## 1 ADDENDUM #1

Project Title:  
**Queen Elizabeth Hospital  
 Mental Health & Addictions  
 Emergency Department &  
 Short Stay Unit**

Project Number:  
**211025**  
 Drawing Number:  
**ASK-AD040**

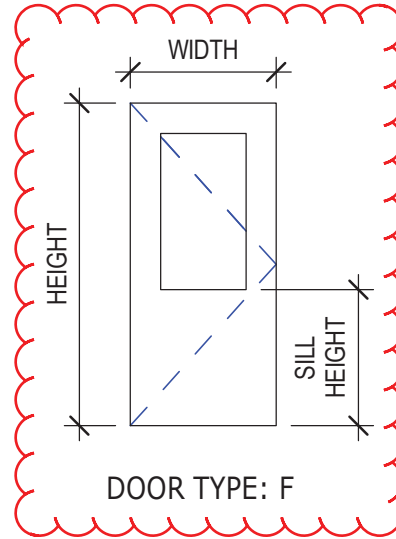
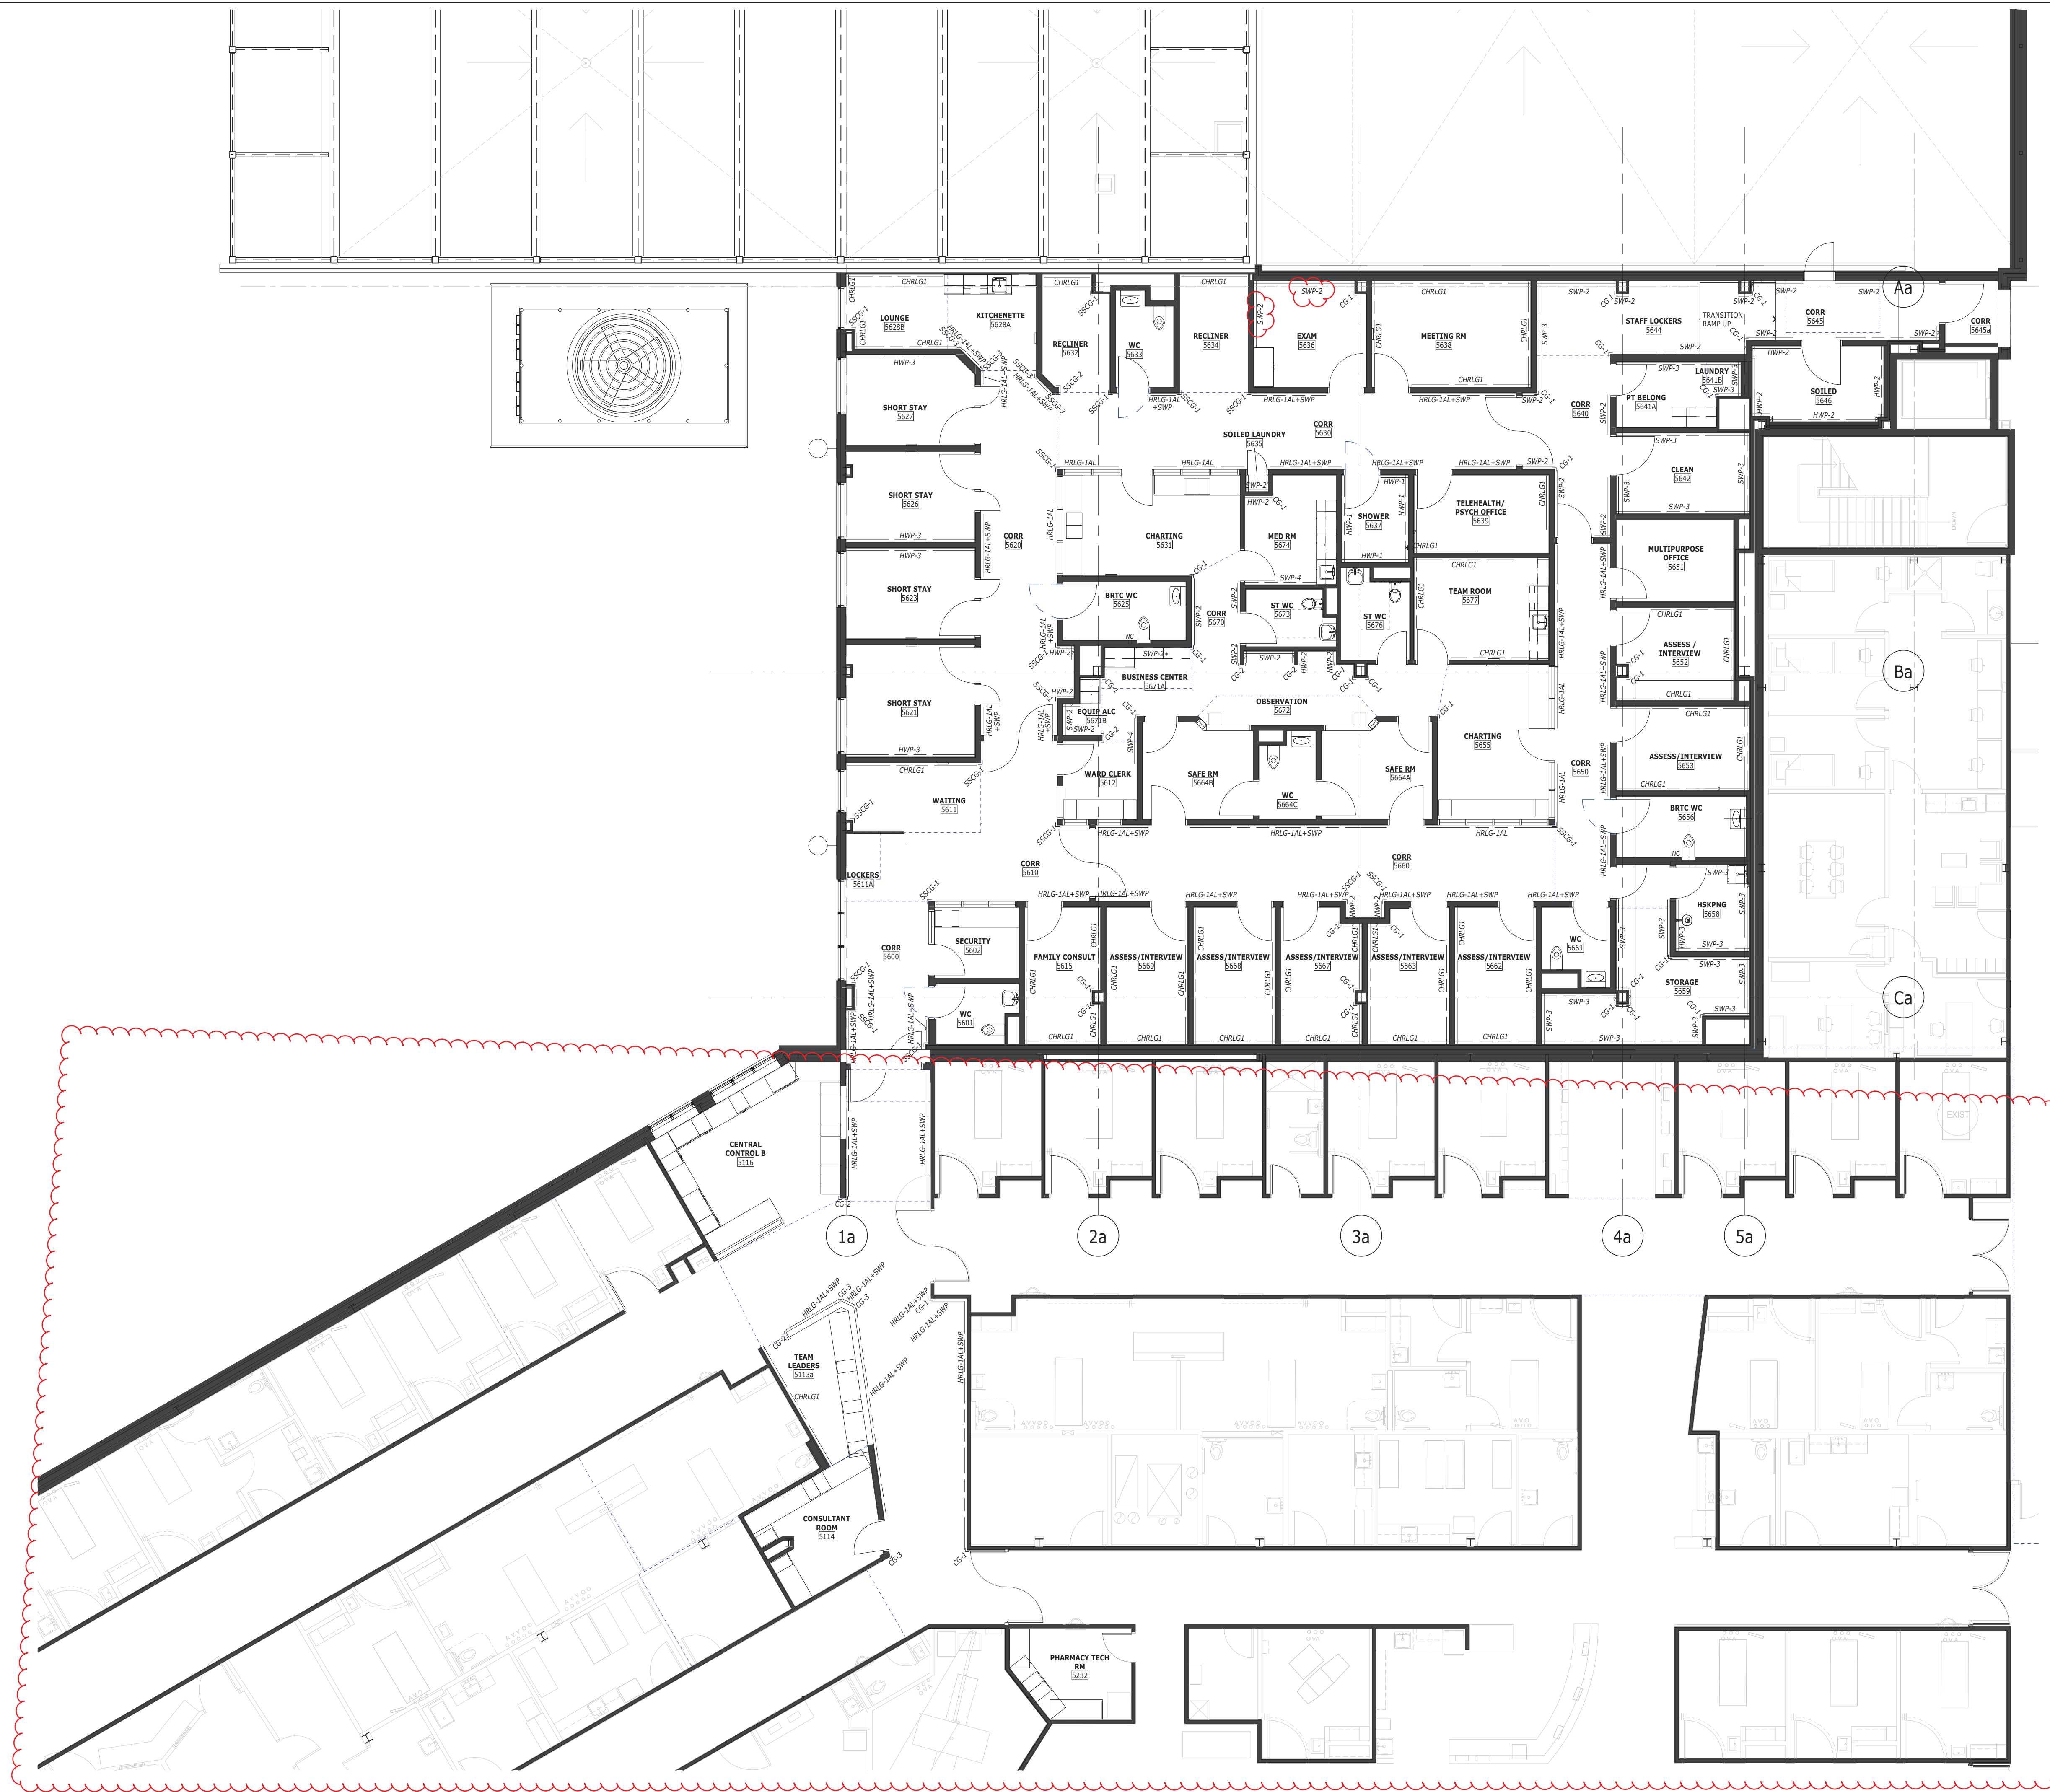
- .1 Reference Detail Sheets AD020 to AD024 (inclusive), AD034 and AD050 to AD075 (inclusive):
  - .1 Delete all instances of the wording "Preliminary Only Not for Construction".
- .2 Reference Detail Sheets AD031 to AD033 (inclusive) and AD040:
  - .1 Delete Detail Sheet AD031 as originally issued and replace with sketch ASK-AD031 - Door Schedule, attached and forming part of this addendum.
  - .2 Delete Detail Sheet AD032 as originally issued and replace with sketch ASK-AD032 - Door Schedule, attached and forming part of this addendum.
  - .3 Delete Detail Sheet AD033 as originally issued and replace with sketch ASK-AD033 - Door Schedule, attached and forming part of this addendum.
  - .4 Delete Detail Sheet AD040 as originally issued and replace with sketch ASK-AD040 - Door Types, attached and forming part of this addendum.

No.	Description	Date	Date	Revision
0	ISSUED FOR TENDER	2022-03-22	January 13, 2022	
1	ISSUED FOR ADDENDUM #1	2022-03-30	DM By: JR	1
			Project Number:	
			211025	
			Drawing Number:	
			A142r1

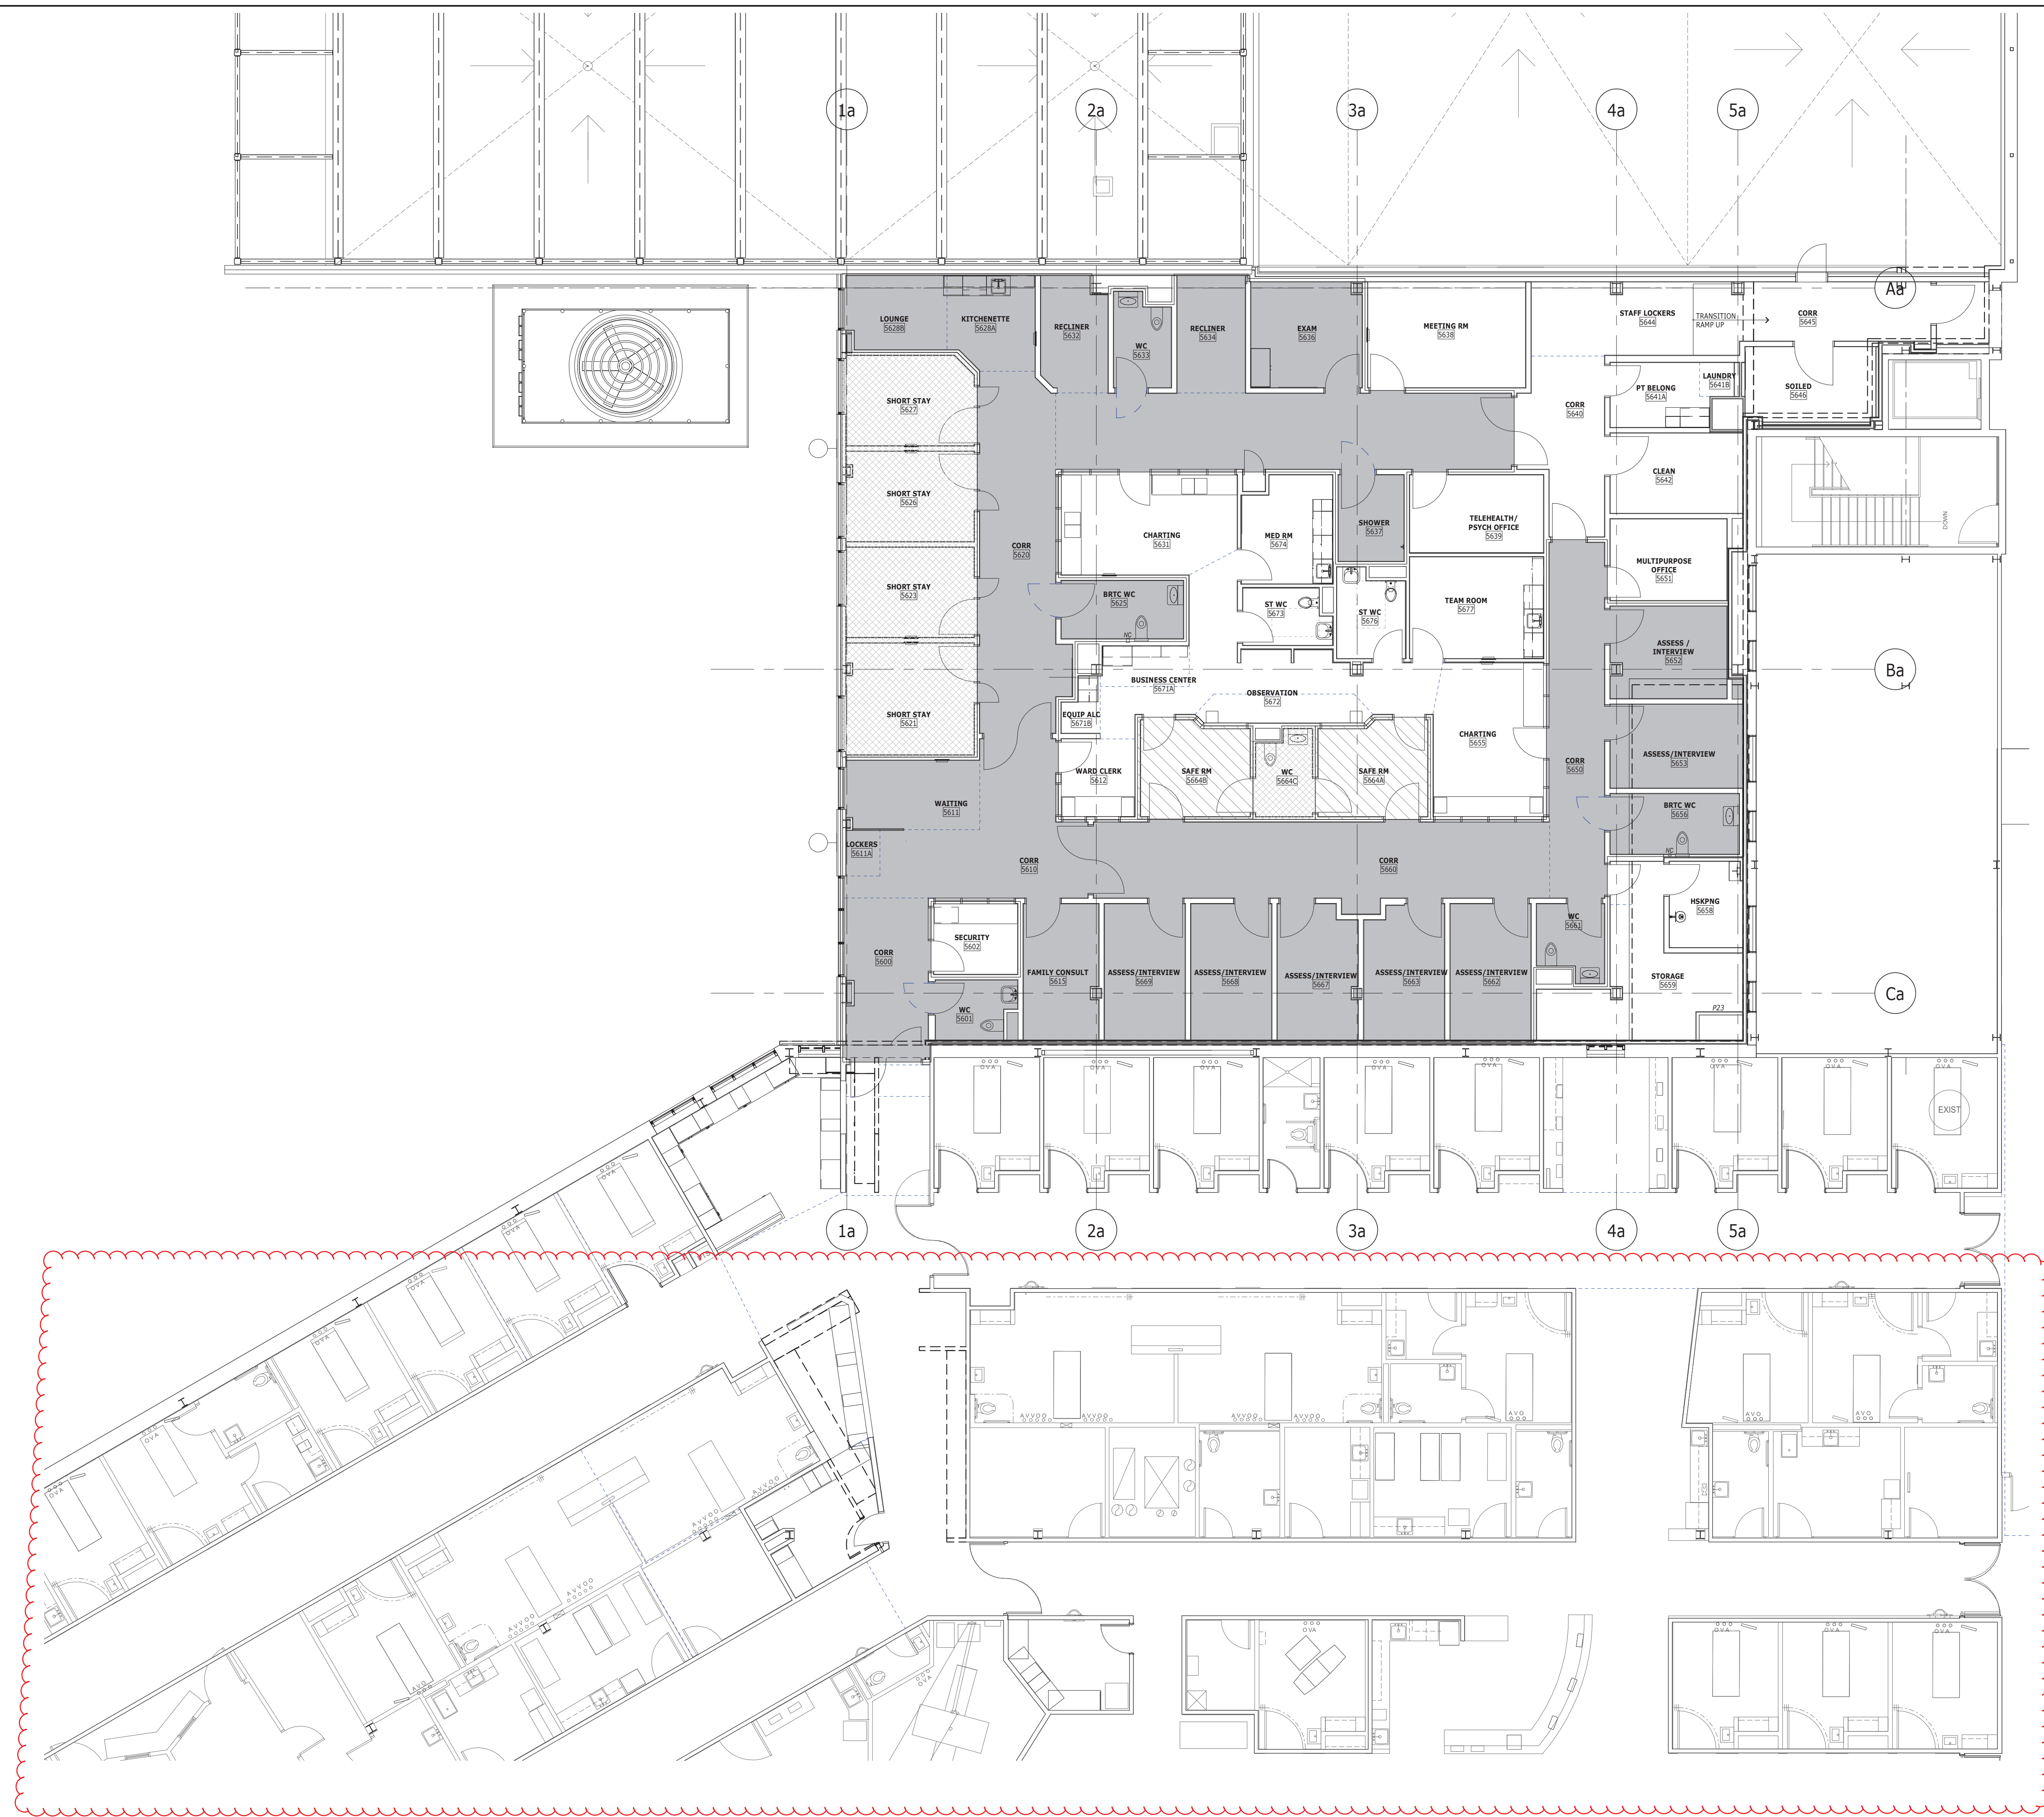
- 
- .3 Reference Drawing A142 - Wall Finishes Plan - Level 200:
    - .1 Delete drawing as originally issued and replaced with revised Drawing A142r1 - Wall Finishes Plan - Level 200 - dated March 30, 2022, attached and forming part of this addendum.
